Sikorsky Aircraft Corporation

SPECIAL SERVICE INSTRUCTIONS

SSI No. 92-121

Subject: ROTOR DRIVES – Main Gear Box (MGB) Oil Pressure, Temperature, and Pump Warning – Installation of Auxiliary Circuit Breaker Panel and M XMSN PRESS SWITCH Circuit Breaker Modification Kits

AUX CB PANEL MODIFICATION
FIGURE 2 (SHEET 1 OF 2)

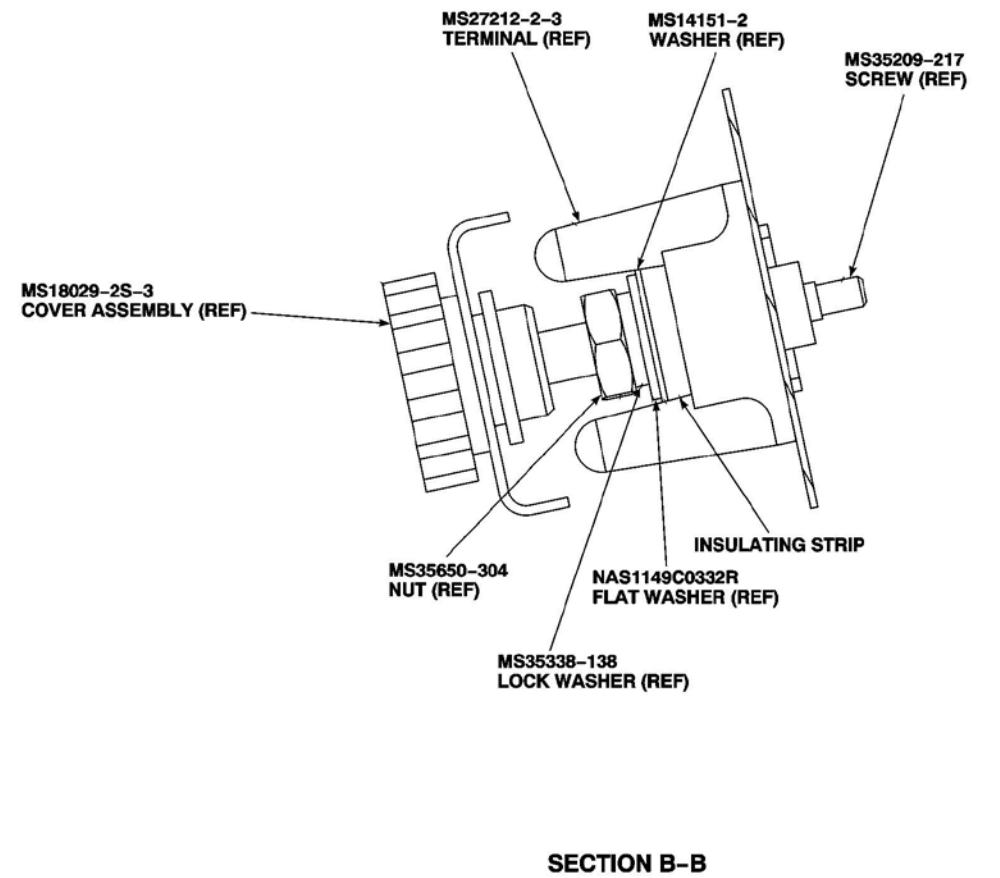
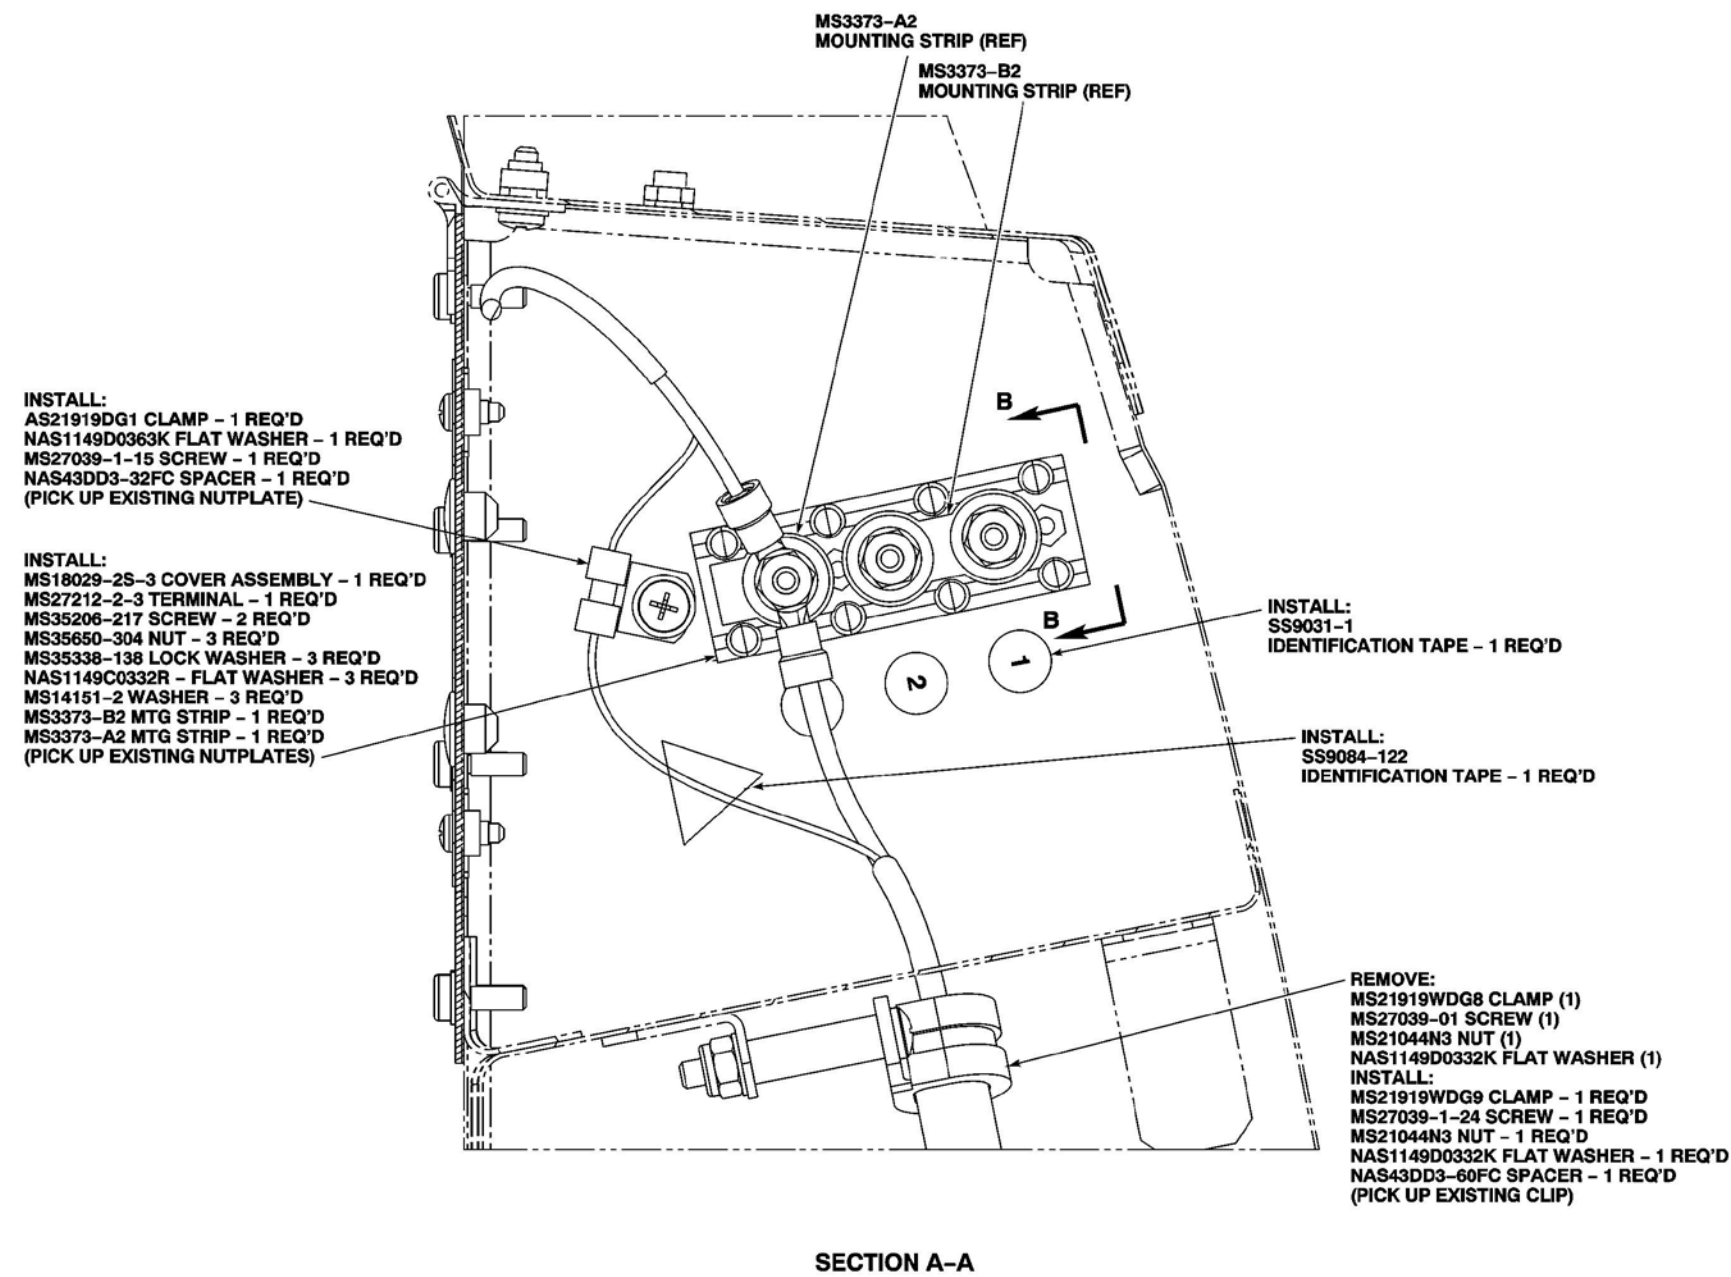
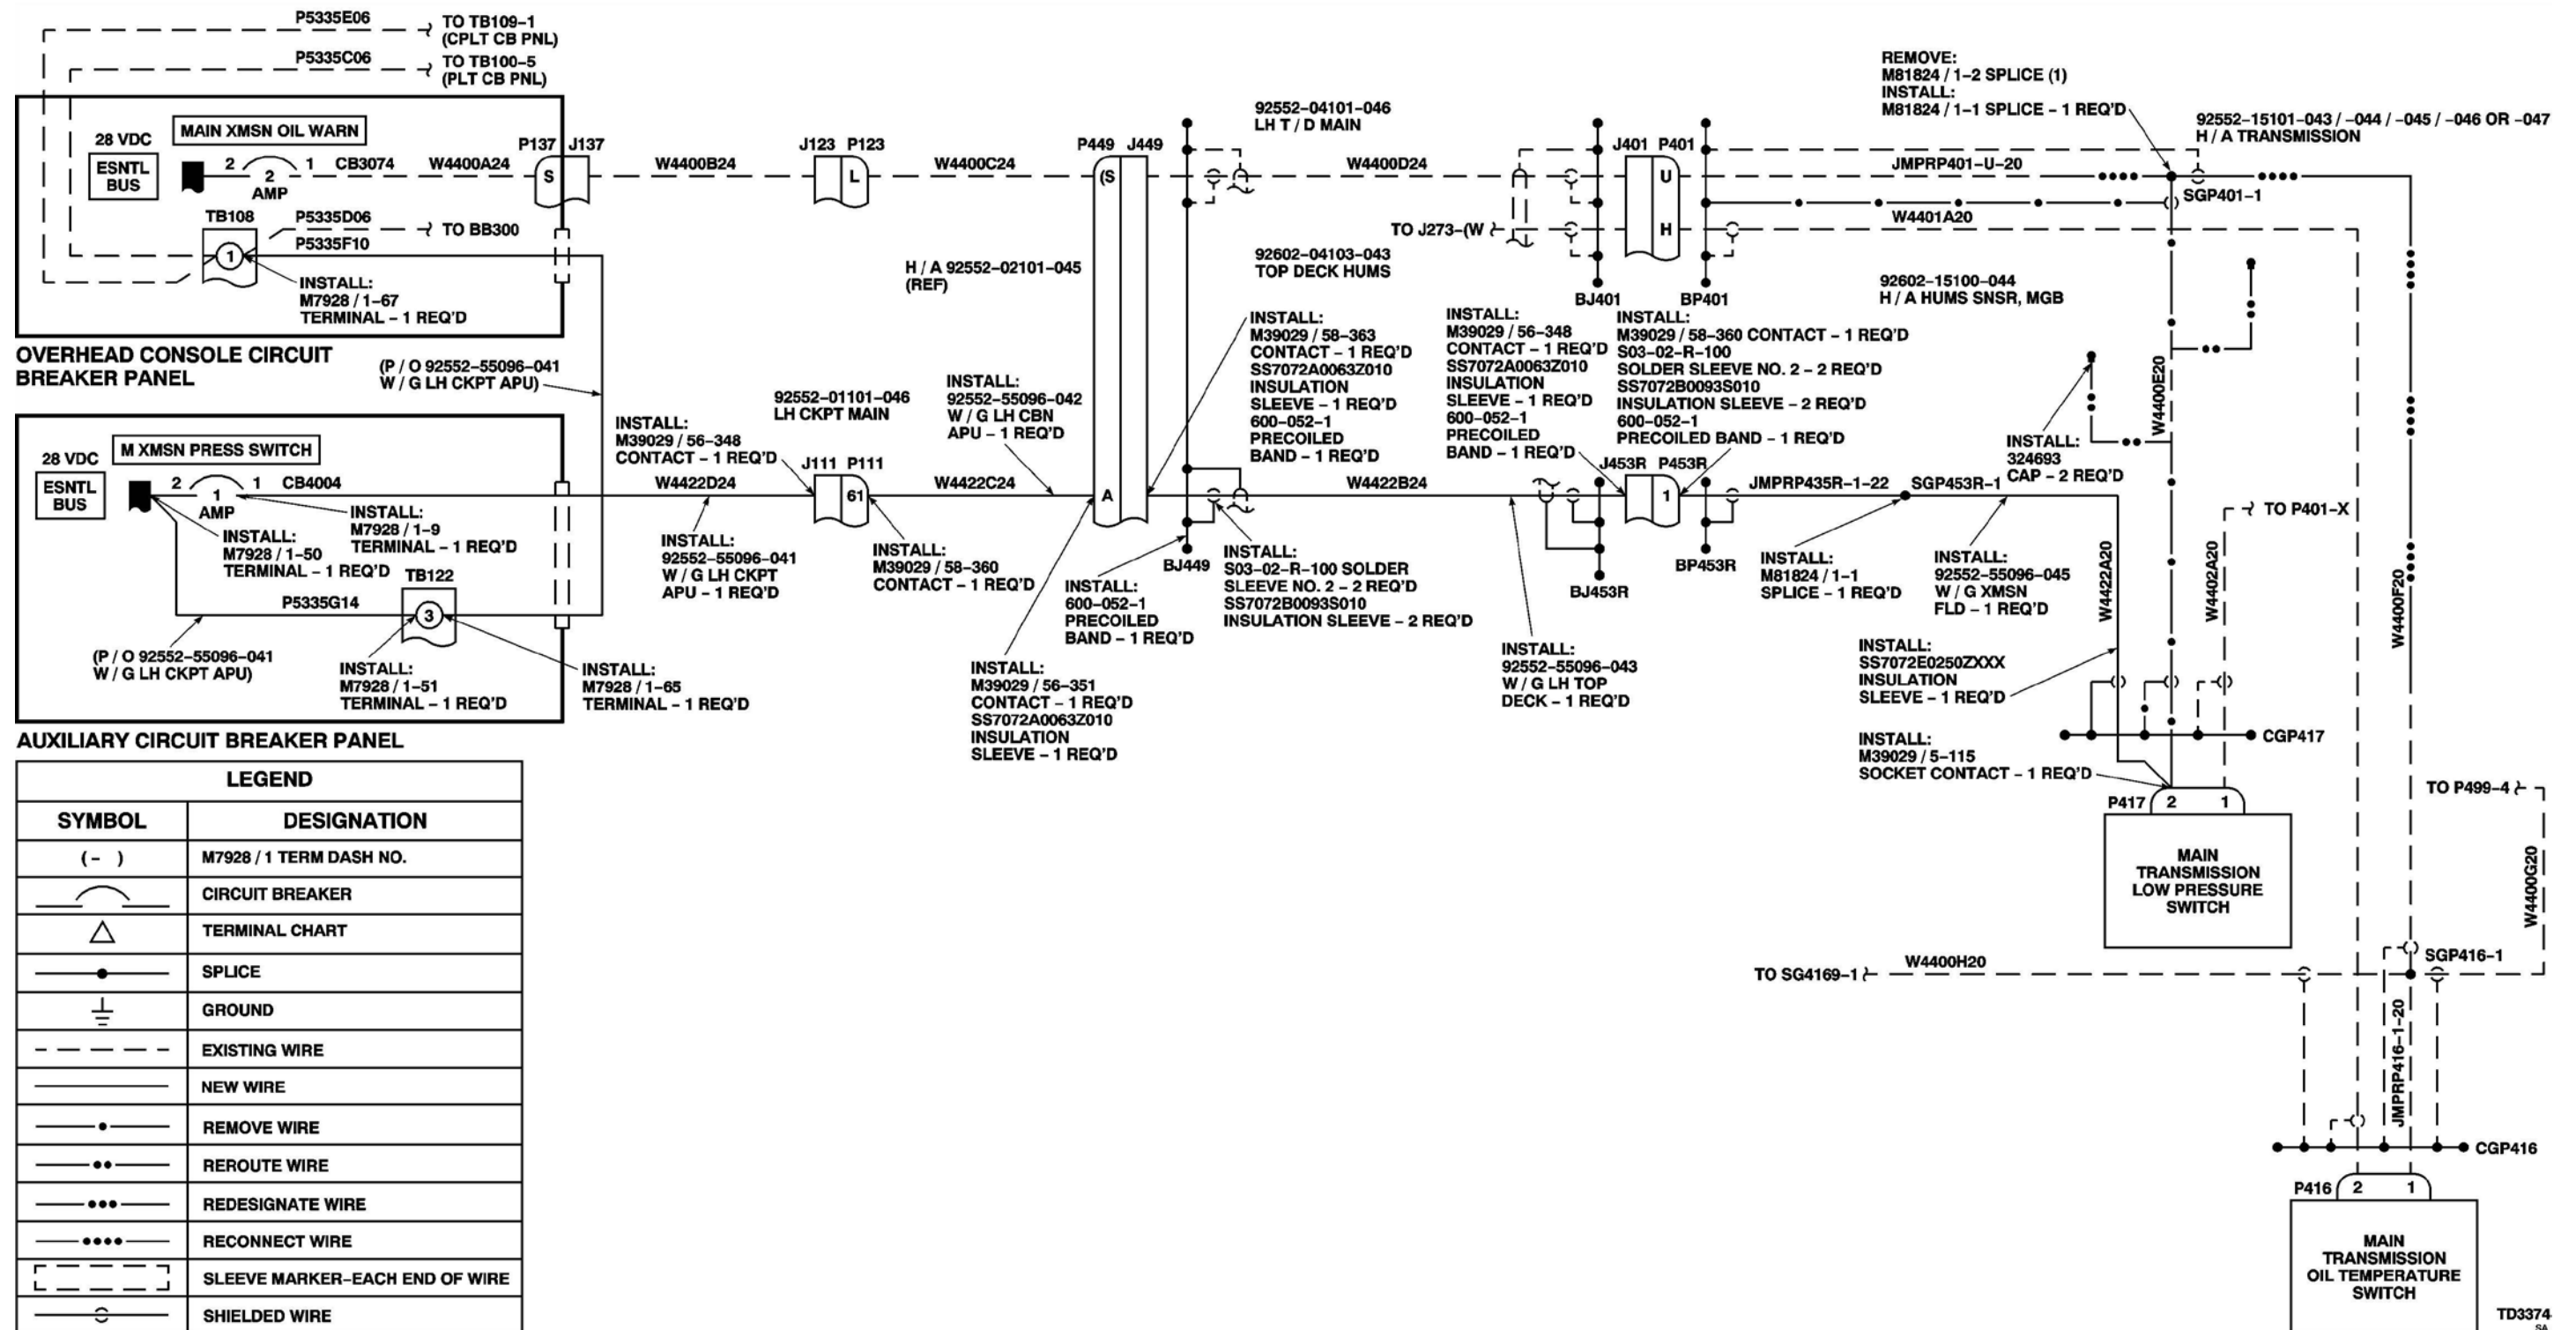
- C. Install portion of Modification Kit Auxiliary Circuit Breaker Panel Provision (M/K, PROV, AUX CB PNL) (92070-55075-011) as follows (Refer to Figure 2, Sheet 1):

- H. Continue installation of M/K, PROV, AUX CB PNL (92070-55075-011) as follows (Refer to Figure 2):

- (1) Cut insulation tubing (SS7114FT02-0050) lengthwise and install on W/G LH CKPT APU (92552-55096-041), and tie to wire bundle using lacing tape (SS7057-2). (Refer to Sheet 1, and Maintenance Manual, SA S92A-AMM-000, Task 20-20-02-910-002).

MGB INDICATIONS WIRING MODIFICATION
FIGURE 3

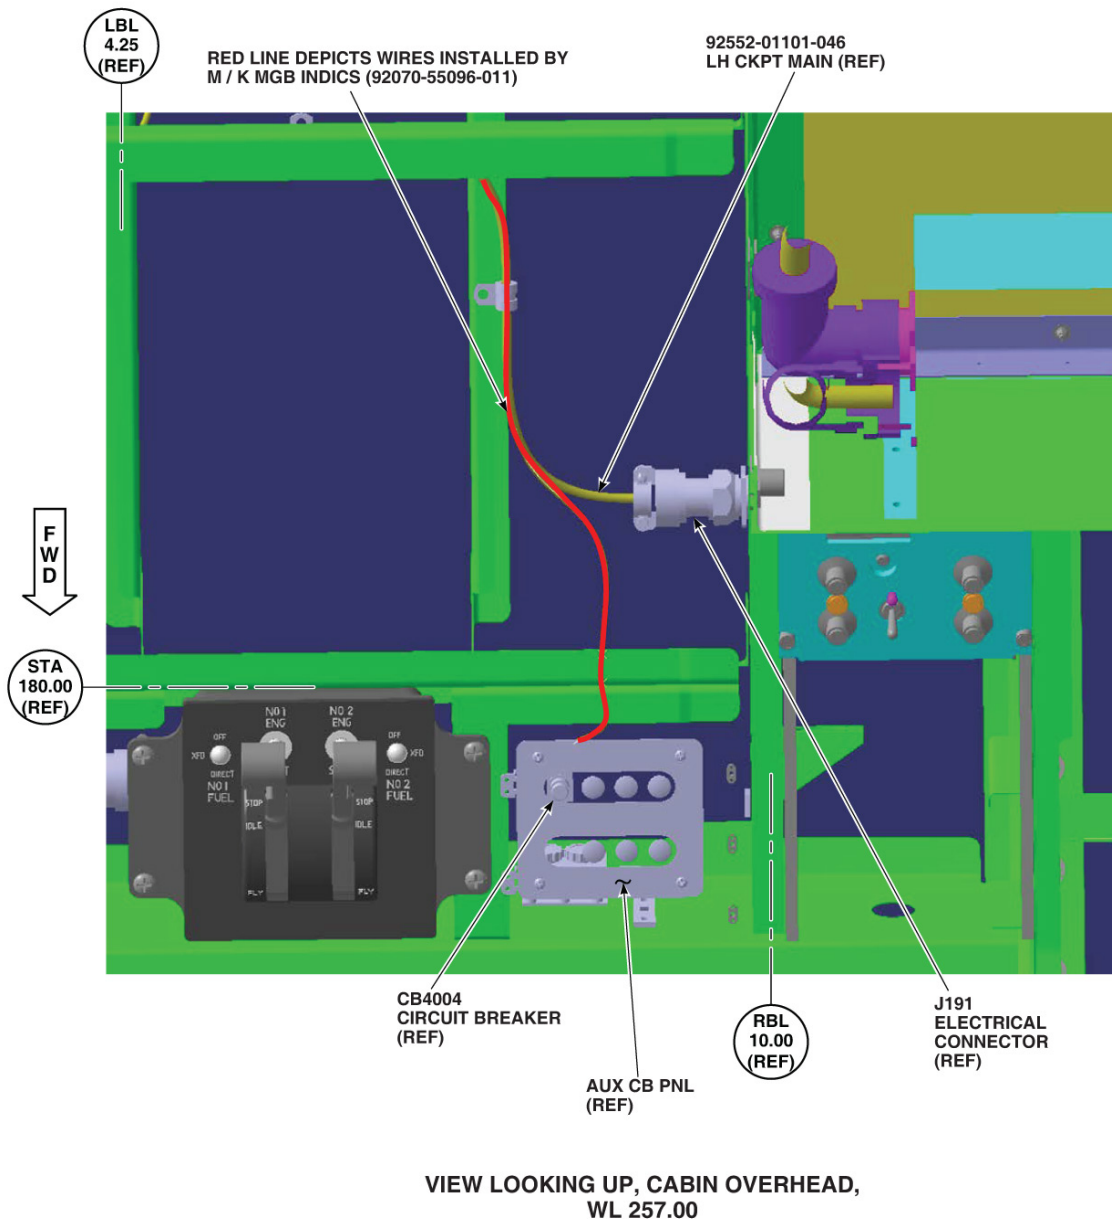
- (1) Install W/G LH CKPT APU (92552-55096-041).
- (2) Route new wire (P5335F10) along existing wiring harness, from terminal board TB108 to terminal board TB122 (Figure 3).
- (3) Install terminal (M7928/1-67) on end of wire (P5335F10) near terminal board TB108 on OVHD CNSL CB PNL.
- (4) Install terminal (M7928/1-65) on end of wire (P5335F10) near terminal board TB122 on AUX CB PNL.
- (5) Install new wire (P5335F10) on terminal board TB108-1 and terminal board TB122-3.

- (13) Install terminal (M7928/1-9) on end of wire (W4422D24) near M XMSN PRESS SWITCH on AUX CB PNL (Figure 3).
 - (14) Crimp contact (M39029/56-348) on end of wire (W4422D24) near electrical connector (J111).

- (3) Install insulating sleeve (SS7072A0063Z010) on wire (W4422C24) near electrical connector (P111) (Figure 3).
- (4) Crimp contact (M39029/58-360) on end of wire (W4422C24) near electrical connector (P111).

- (3) Install solder sleeves (S03-02-R-100), insulating sleeves (SS7072B0093S010), and precoiled bands (600-052-1) on wire (W4422B24) (Figure 3).
- (4) Crimp contact (M39029/58-363) on end of wire (W4422B24) near electrical connector (J449).

G. Install Modification Kit MGB XMSN (92070-55096-017) as follows:

- (5) Install solder sleeves (S03-02-R-100) on wire (W4422A20) (Figure 3).
- (6) Install insulated sleeves (SS7072B0093S010) on wire (W4422A20).
- (7) Install precoiled band (600-052-1) near electrical connector (P453R).

- (10) Crimp socket contact (M39029/5-115) on end of wire (W4422A20) near electrical connector (P417).
- (11) Remove splice (M81824/1-2) at splice group (SGP401) from wires (W4400F20, W4400E20, and JMPRP401-U-20) (Figure 3).

WIRE ROUTING FOR M/K LH COCKPIT AUXILIARY POWER UNIT (92070-55096-012)
BEGINNING OF ROUTE
FIGURE 4 (SHEET 1 OF 2)

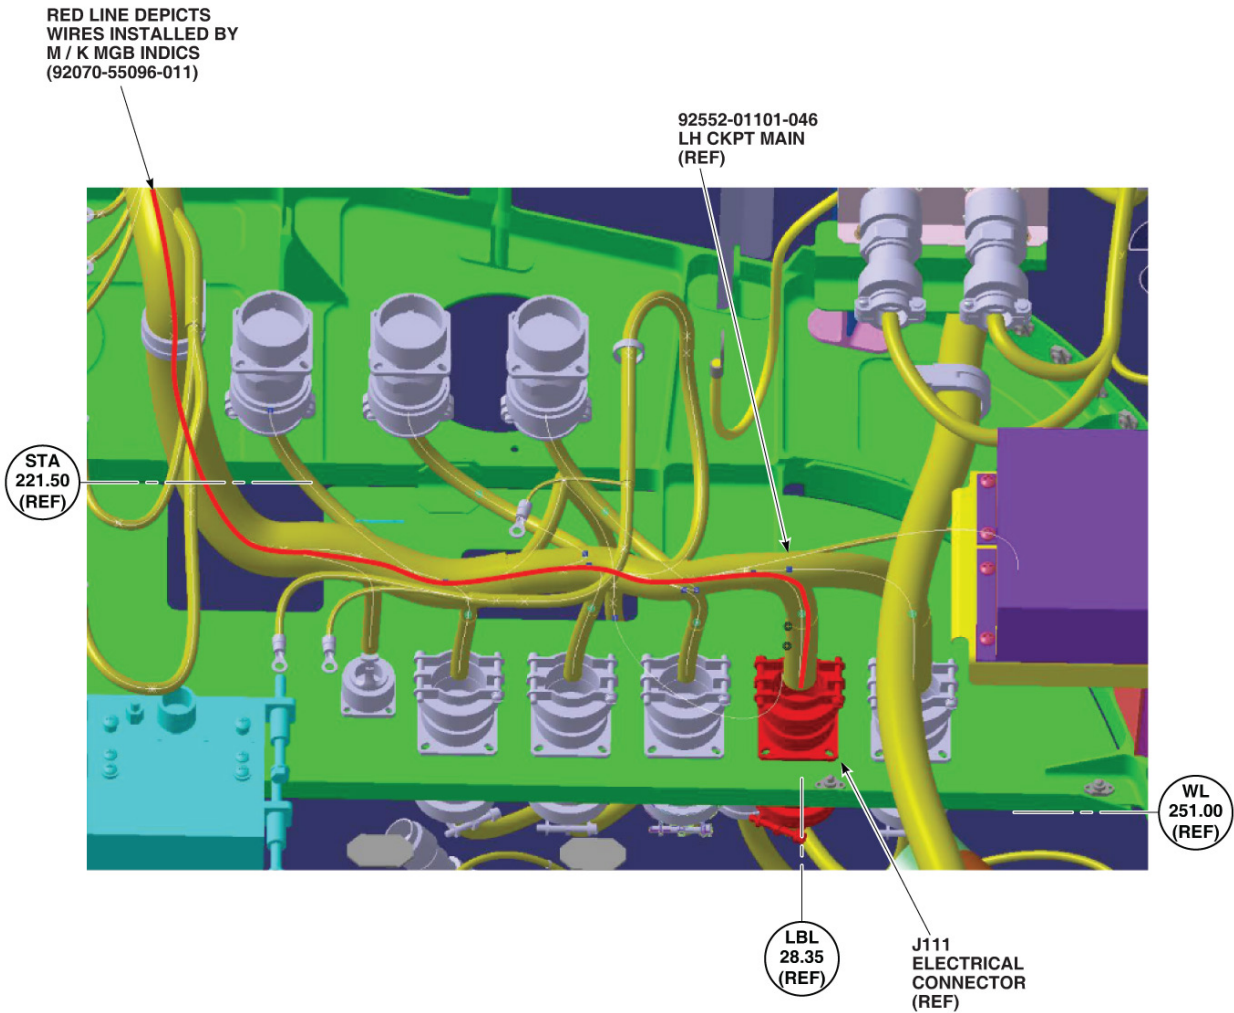
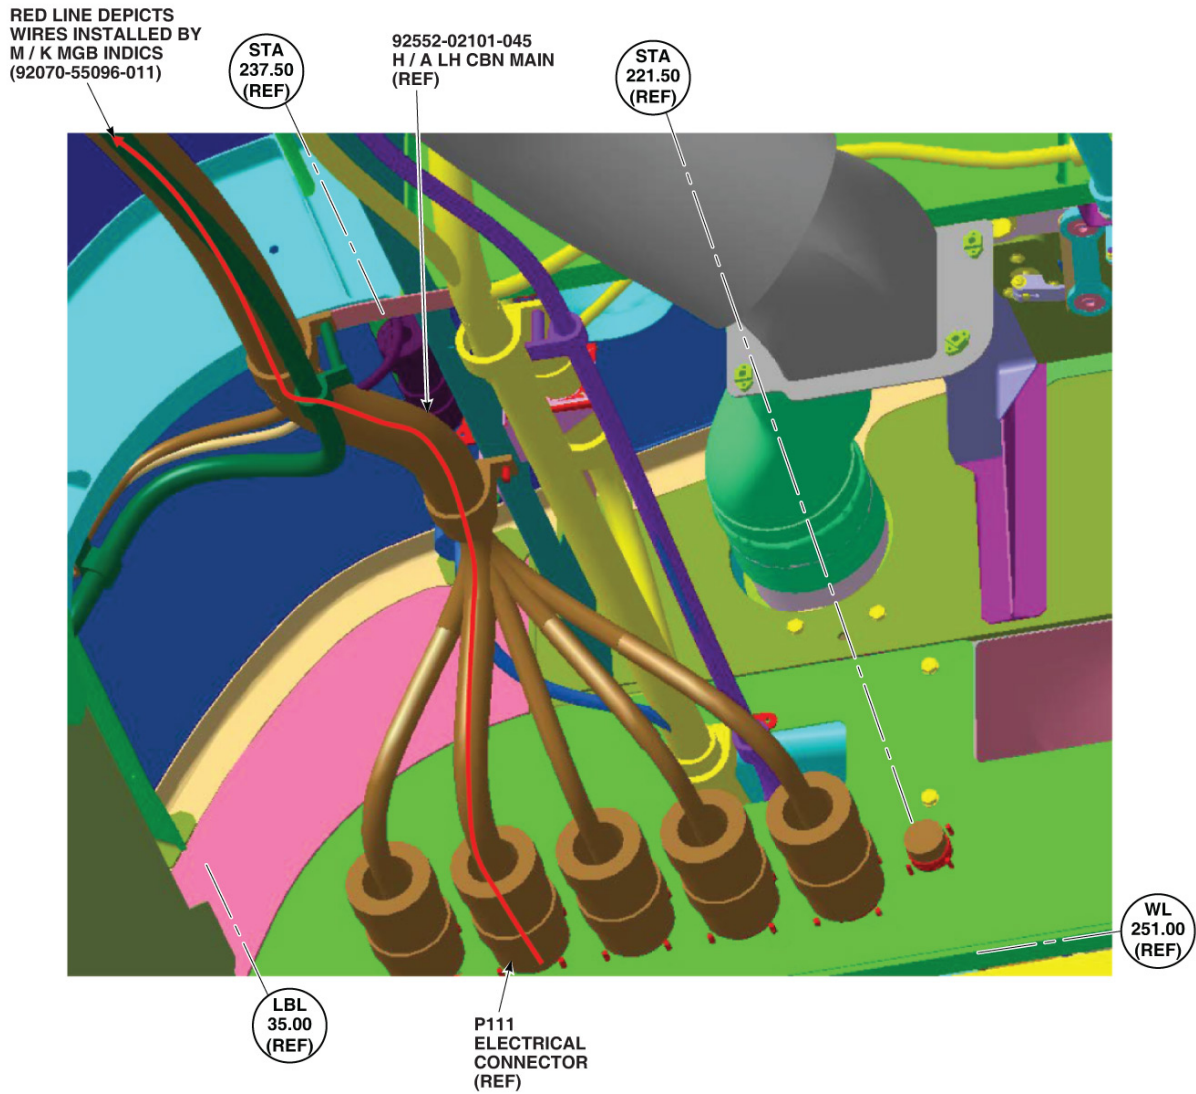
- (12) Route new wire (W4422D24) along existing wiring harness LH cockpit main (92552-01101-046), from M XMSN PRESS SWITCH circuit breaker (CB4004) near station (STA) 180.00, Right Buttline (RBL) 10.00, Water Line (WL) 257.00, to electrical connector (J111) near STA 221.50, Left Butt Line (LBL) 28.35, WL 251.00 (Figure 4, Sheets 1 and 2).
